TECHNICAL BULLETIN

NO. 407-96-2

MODELS AFFECTED: 407

SUBJECT: **MODIFICATION FOR INCREASE IN V_{NE} ,
INTRODUCTION OF.**

Figure 1. Stabilizer modification

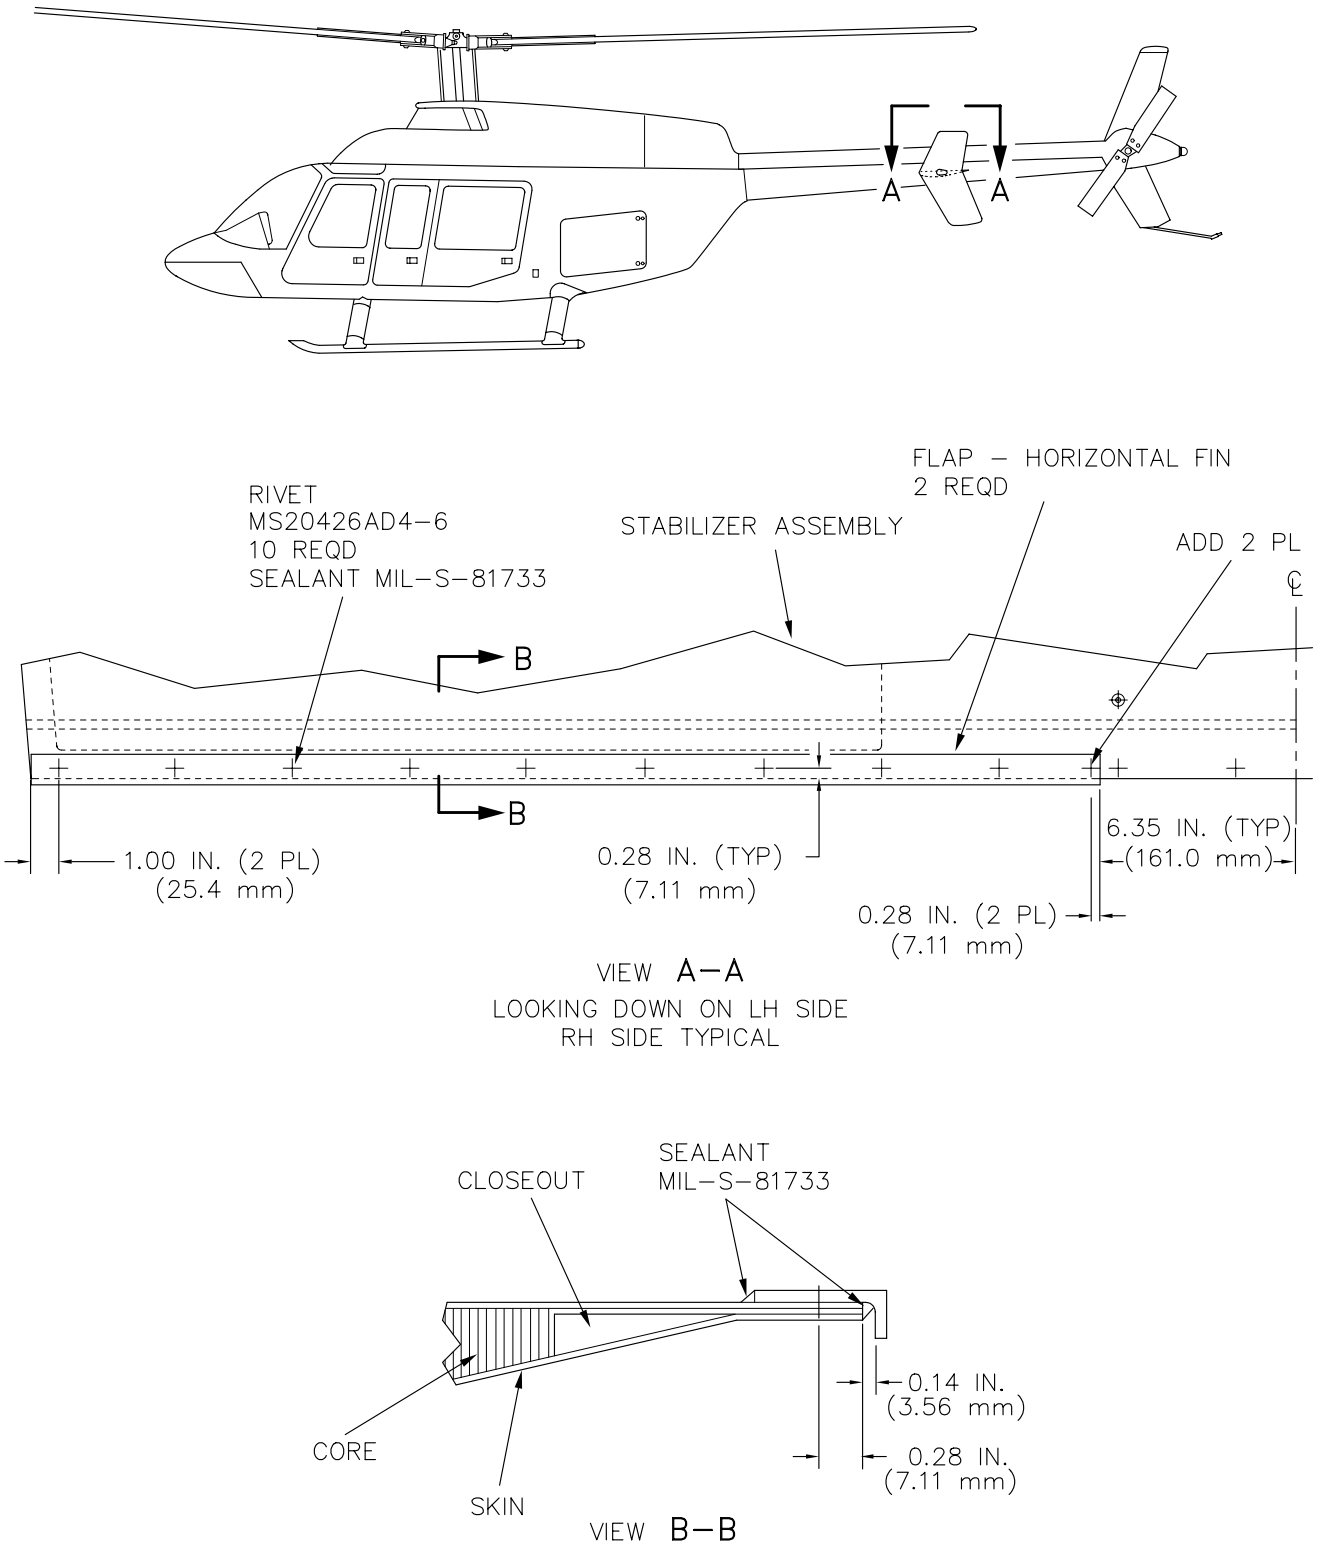
Find the location of the flaps P/N 407-023-802-119 (qty.2). Refer to Figure 1. One flap is installed on the upper surface of each horizontal stabilizer along the trailing edge. The short leg of the flaps "L" extrusion points down. Remove and discard the rubber corner caps P/N 204-031-072-003 from the ends of the trailing edge.

6. Mark the rivet holes on each flap, refer to the applicable Figure. Measure and include the specified edge distances.
 - 6a. Put the flaps P/N 407-023-802-119 in position on the horizontal stabilizer. With the use of the horizontal stabilizer rivet holes backdrill the flaps. One more rivet hole is necessary on the inboard edge of the flap, refer to Figure 1.

Figure 2. Vertical fin modification

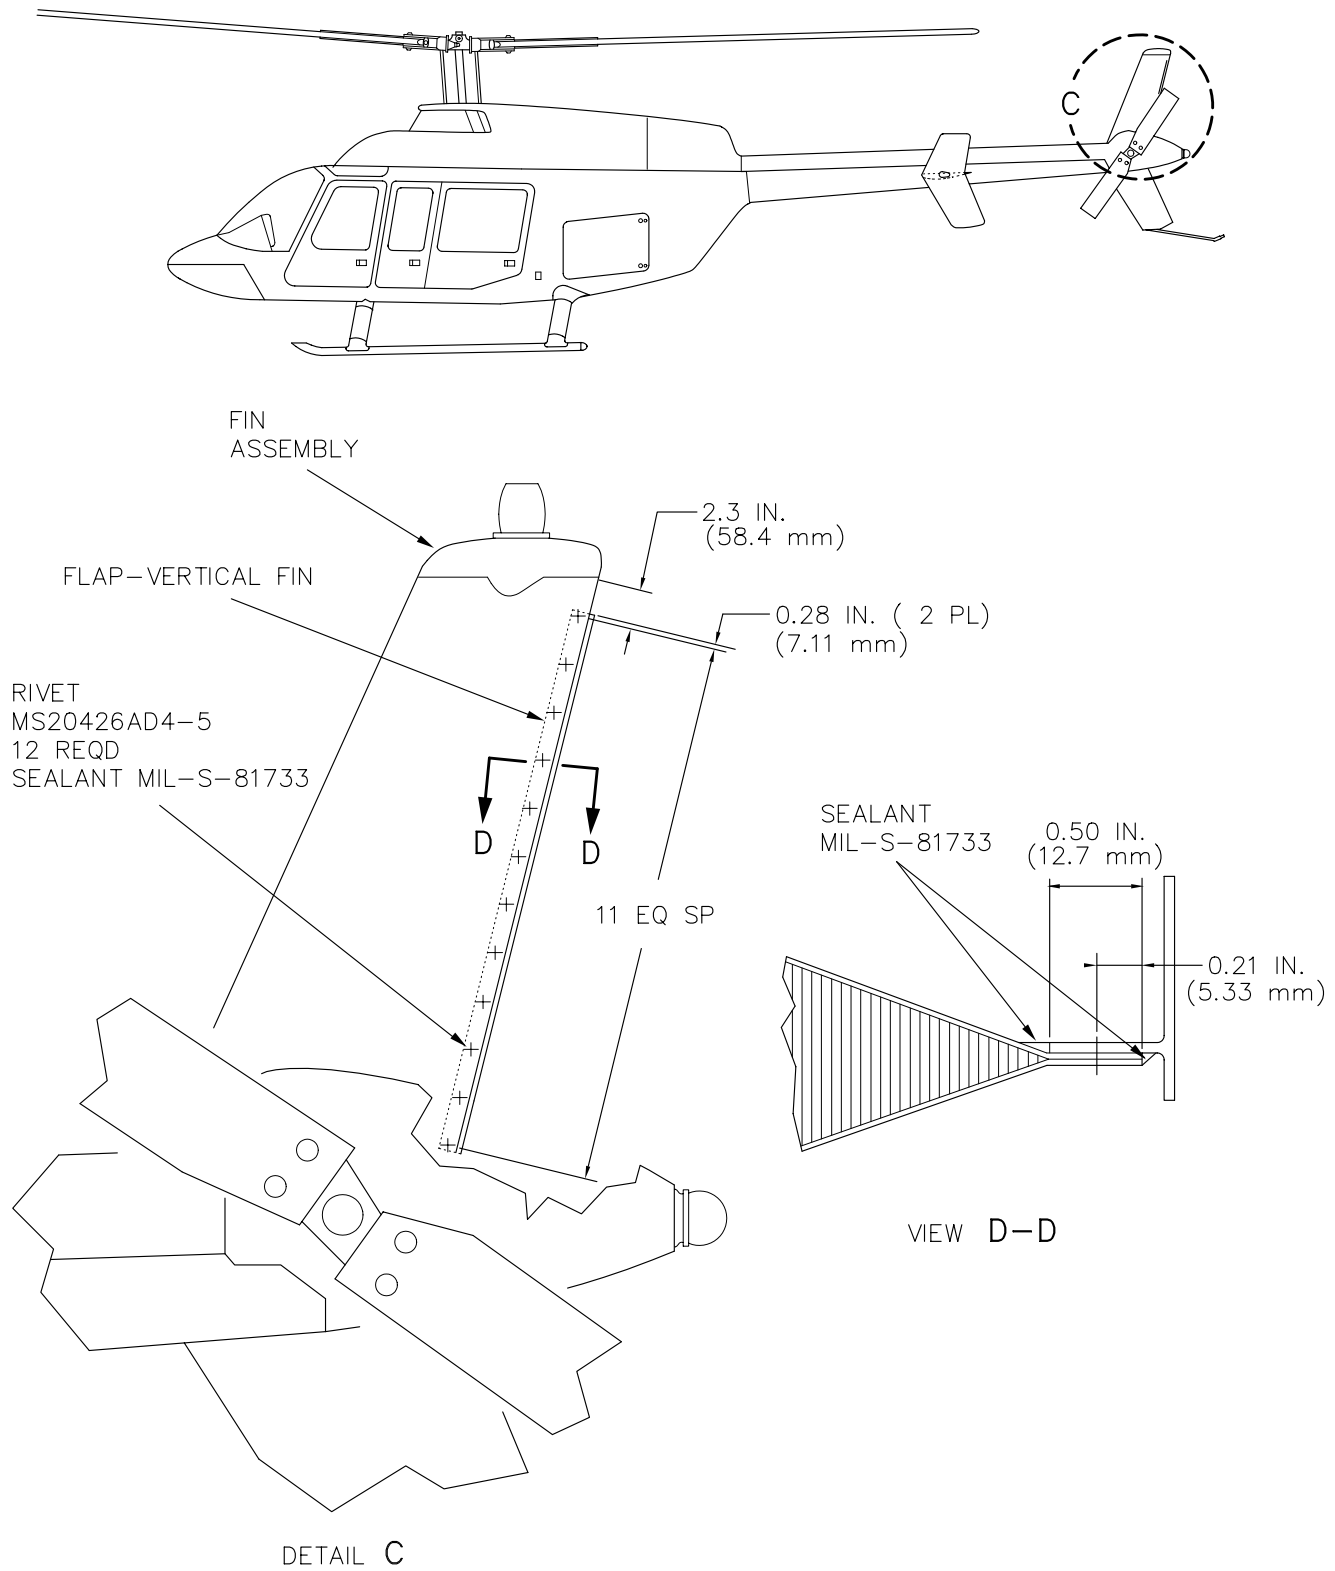
Find the location of the flap P/N 407-023-802-117. Refer to Figure 2. The flap is installed on the right side along the upper trailing edge of the vertical fin. The long leg of the flap "T" extrusion points outboard.
